Microfilm Data Input Form

DRAINAGE VARIANCE

Title: DRAINAGE VARIANCE

Description: LAKEPOINT B96CS005

GRADING AND DRAINAGE PLAN
 Project Number 95255.00
 February 9, 1996

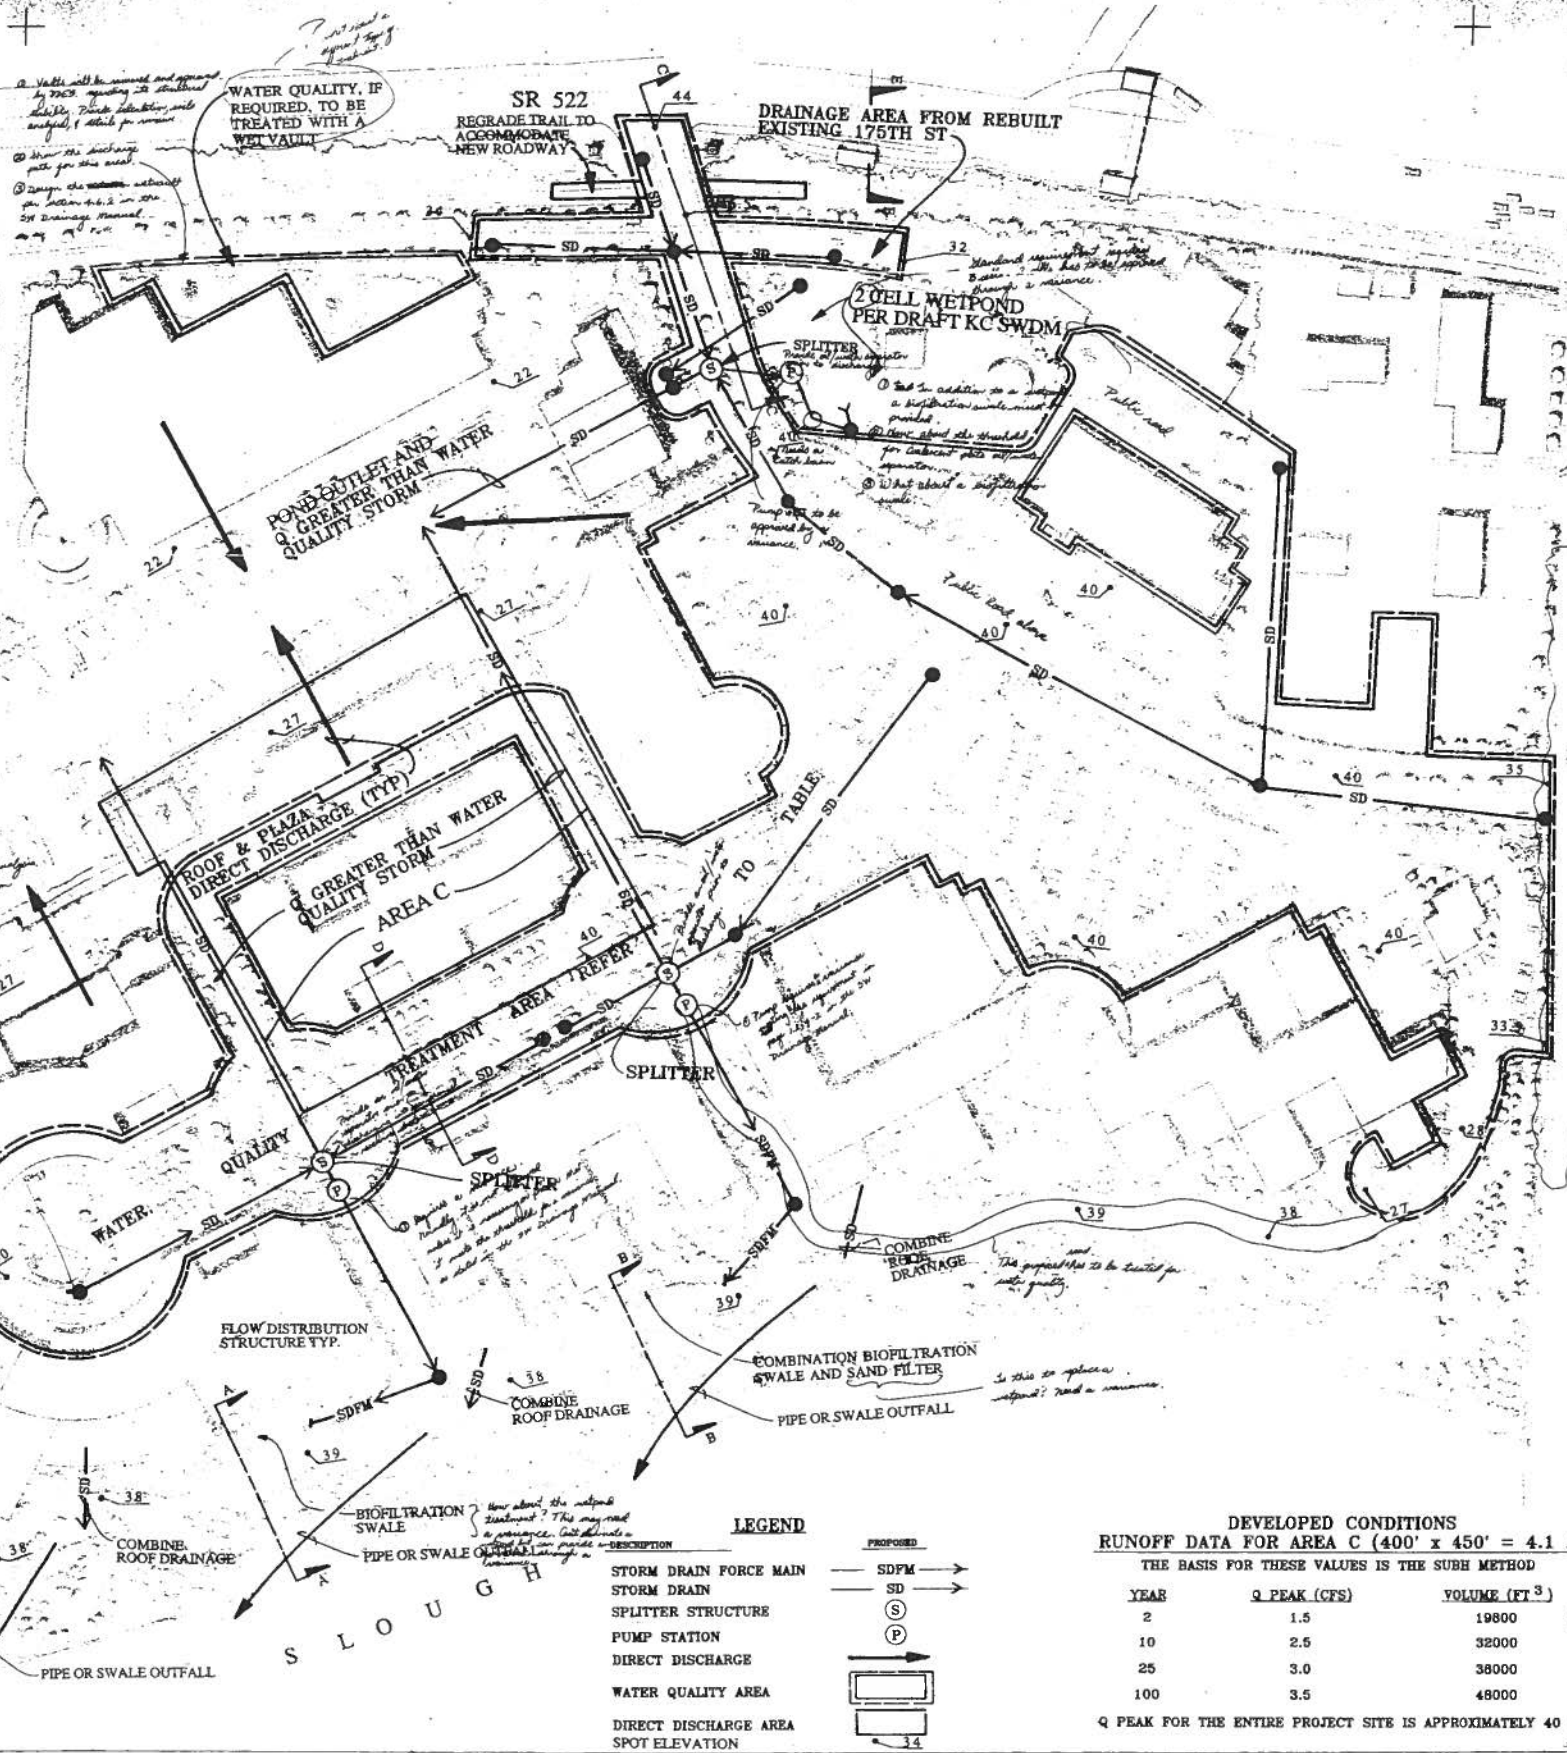
Comments by Donato Ickelsohn Drainage
